# Access Compliance Report

## Public Rights-of-Way

### (Pedestrian Signals)

Intersection ID: N/A	Main Street:	Cross Street: N/A	Location: N/A
ADA ID: B7D3616FA530	Signal Type: One Push Button-Non APS	Overall Compliance: No	Severity Score: BTN 1: N/A BTN 2: N/A No BTN: N/A
Codes/Mitigation Info/Possible Solution		Field Measurements/Component Compliance

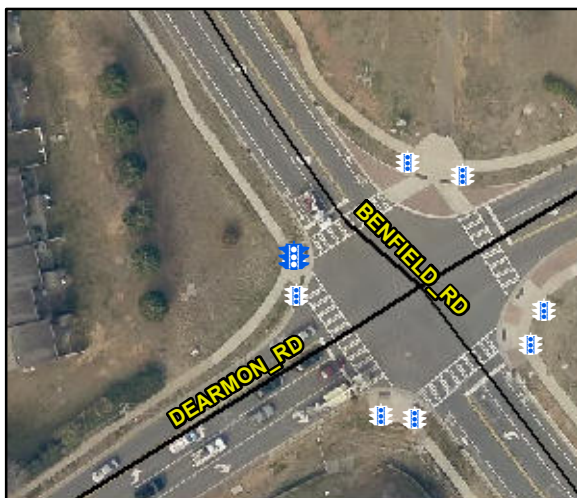
PROW/ADA: TMUTCD 4e.08, R404.2, R404.3

Possible Solutions: Replace Signal Push Button With APS Button on New Post. Remove & Relocate Sign.
